PROPOSED MODIFICATIONS (2016)

RANDALL SCHOOL | PUD Modification

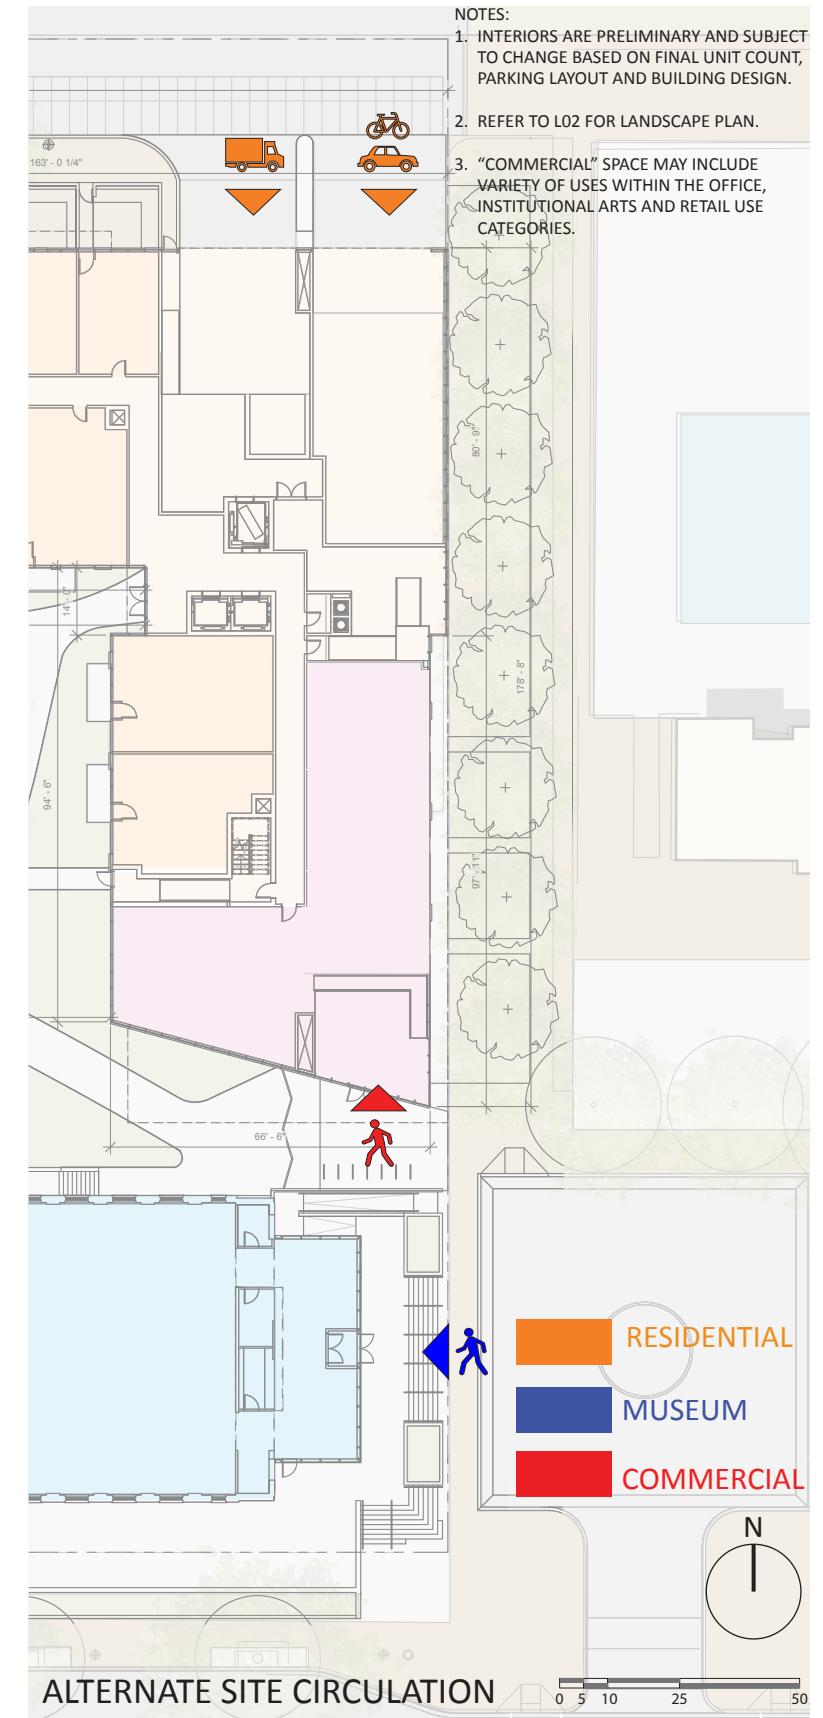
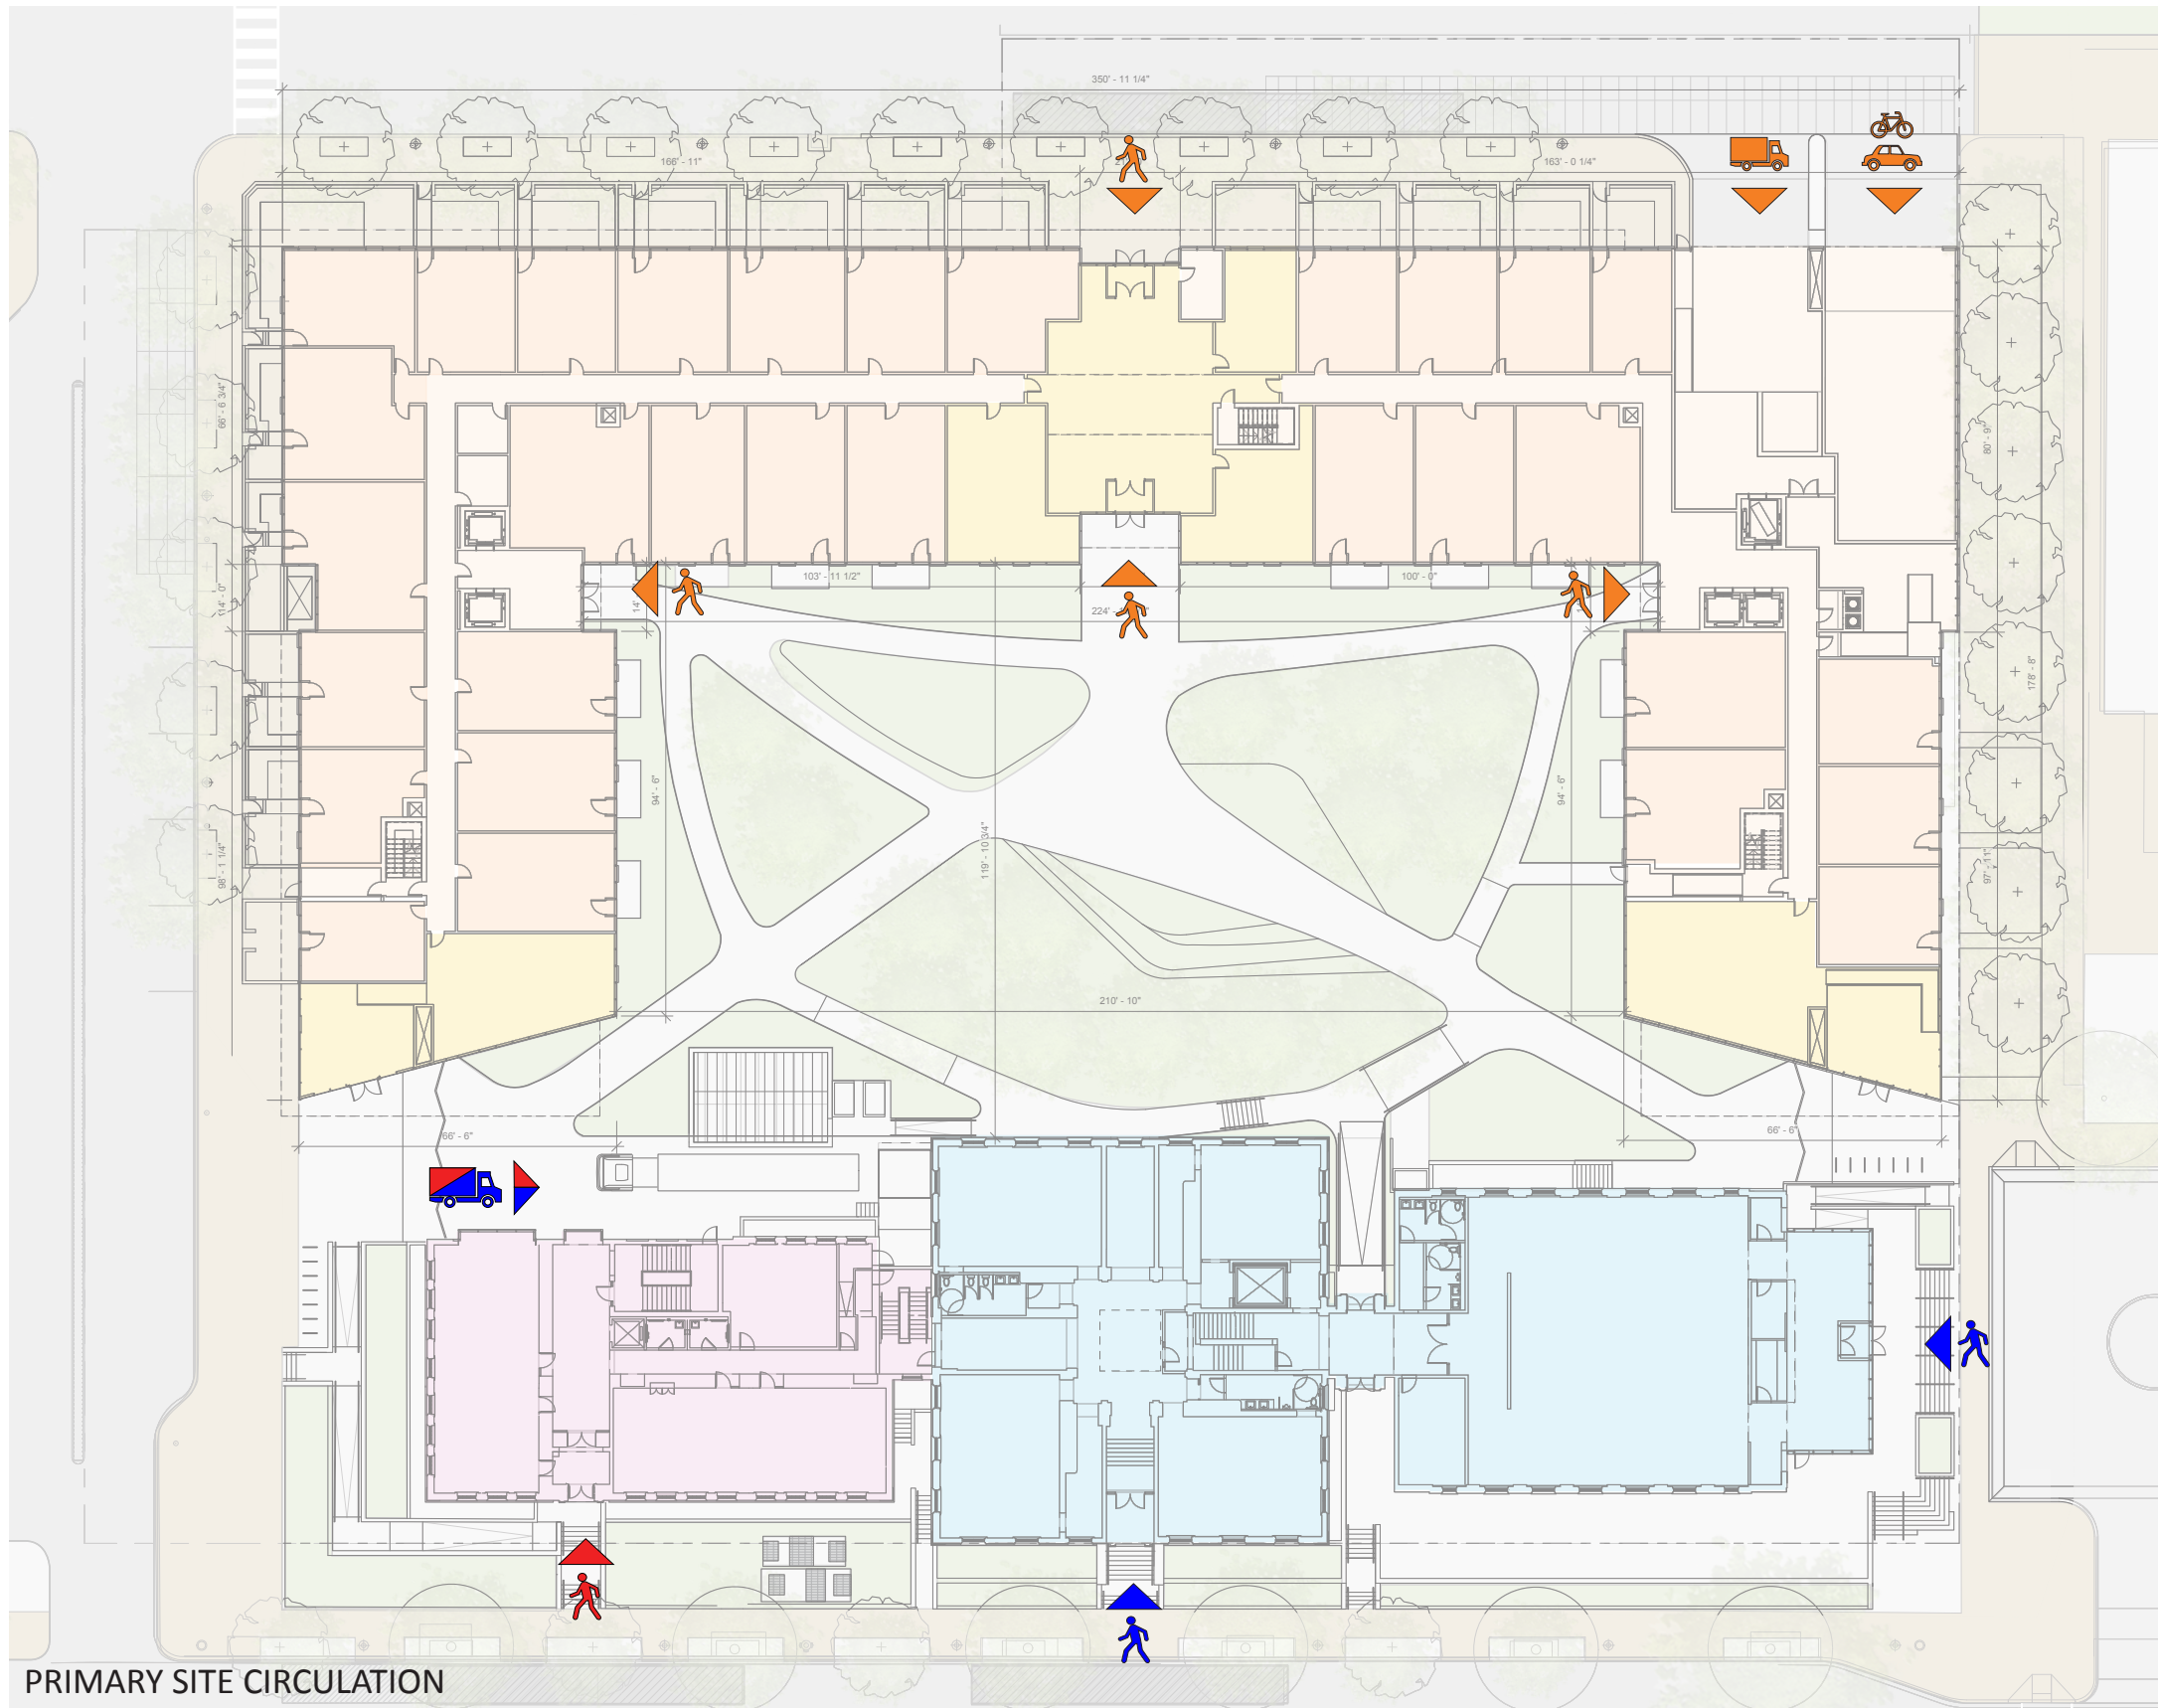
1. MORE REGULARIZED METAL PANEL AND GLASS PATTERN
2. LARGER, OCCUPIABLE BALCONIES ADDED VERSUS PREVIOUS JULIET BALCONIES ON THE UPPER FLOORS 7-12
3. MORE ARTICULATION OF MASSING BETWEEN THE FLOORS 1-6 AND FLOORS 7-12 TO BREAK DOWN THE MASSING
4. MORE GLASS ADDED AT THE PENTHOUSE AMENITY SPACES
5. RESIDENTIAL BUILDING FACADE SIMPLIFIED TO ACT AS BACKDROP TO AND TO HIGHLIGHT DETAILED HISTORIC RANDALL SCHOOL
